# CERTIFICATE OF APPROPRIATENESS PLACARD

516 N BLOODWORTH STREET

- Replace gutters;
- alter rear and rear/side windows and doors

**From:** Tully, Tania  
**Sent:** Thursday, June 29, 2017 5:24 PM  
**To:** 'Bob Doster'  
**Cc:** Robb, Melissa  
**Subject:** COA for 516 N Bloodworth Street

**A2**

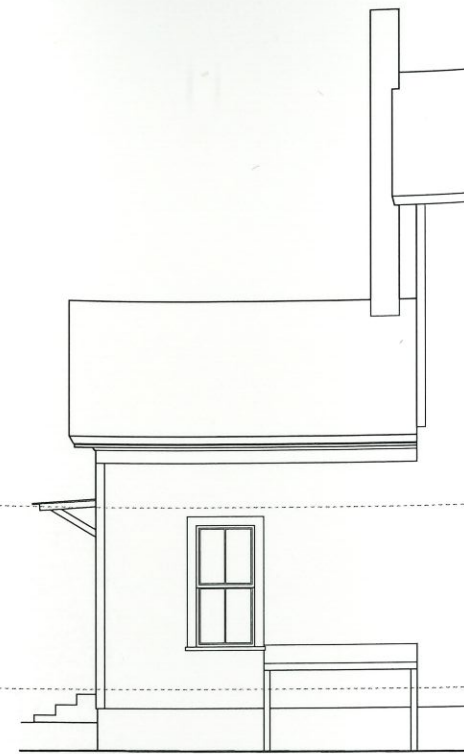
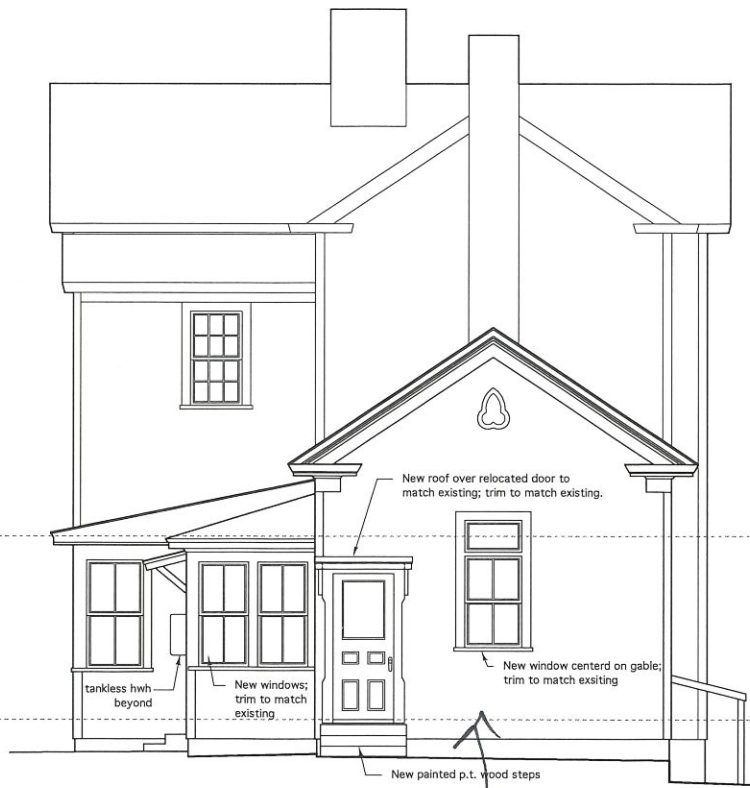
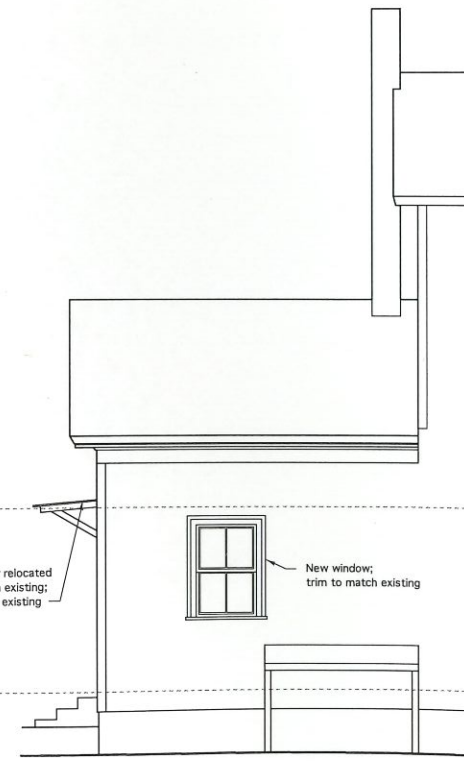
- Please send an electronic version of the plans. The hard copy submitted is too small to be legible. Another option is to bring by an 11x17 printout of the drawing.
- What is the profile of the exterior "grids" on the new doors and windows? Putty is typical.
- Please provide a close-up photo of a muntin being matched. 1-1/8" wide "grids" are not unheard of, but atypical.
- Why aren't the two windows proposed for removal (and replaced with the French doors) being reused on the rear?
- Are light fixtures being removed or reused?
- It appears as though the gutters being replaced are at the rear. Is that correct?

- ✓ What is the profile of the exterior “grids” on the new doors and windows? Putty is typical. The window secs only describe the internal profile;
- The manufacturer website ([http://www.lincolnwindows.com/double\\_hung\\_windows\\_2016\\_options\\_traditions.html?panel=7](http://www.lincolnwindows.com/double_hung_windows_2016_options_traditions.html?panel=7)) has specs for most of the products.
- ✓ Please provide a close-up photo of a muntin being matched. 1-1/8” wide “grids” are not unheard of, but atypical.
- ✓ Please confirm that no external gutters will be added where they do not exist. There appear to be internal gutters on the front/historic portion of the house.

-We have attempted to forward an electronic copy of the plans. The file size is too large for your office server to receive due to photos of the property the architect embedded in the plan. It cannot be received by your server as a compressed version either. Is there another address where we may send the plans? If not, we will hand deliver a copy on 11x17 this morning.

*new/replaced siding to be woven w/ existing to avoid matching vertical seams*

GRID OPTIONS - STANDARD PRODUCTS  
 SCALE: 6" = 1' 0"  
**LINCOLN WOOD PRODUCTS, INC.**  
 1400 W. TAYLOR ST. Merrill, WI 54452 (715) 536-2461

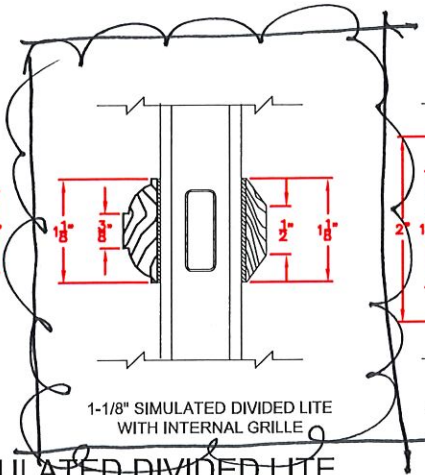
- Please send an electronic version of the plans. The hard copy submitted is too small to be legible. Another option is to bring by an 11x17 printout of the drawing.
- What is the profile of the exterior “grids” on the new doors and windows? Putty is typical.
- Please provide a close-up photo of a muntin being matched. 1-1/8” wide “grids” are not unheard of, but atypical.

- What is the profile of the exterior “grids” on the new doors and windows? Putty is typical. The window secs only describe the internal profile;
- The manufacturer website ([http://www.lincolnwindows.com/double\\_hung\\_windows\\_2016\\_options\\_traditions.html?panel=7](http://www.lincolnwindows.com/double_hung_windows_2016_options_traditions.html?panel=7)) has specs for most of the products.
- Please provide a close-up photo of a muntin being matched. 1-1/8” wide “grids” are not unheard of, but atypical.
- Please confirm that no external gutters will be added where they do not exist. There appear to be internal gutters on the front/historic portion of the house.

I am waiting on Tim at American Cedar to send exterior specs. Will get them to you asap. The windows he is quoting are from your per-approved list.

Please find attached photos of existing window panel dividers. They appear to be approximately 3/4 " wood with putty. Overall is approximately 1 1/8". From putty edge to putty edge.
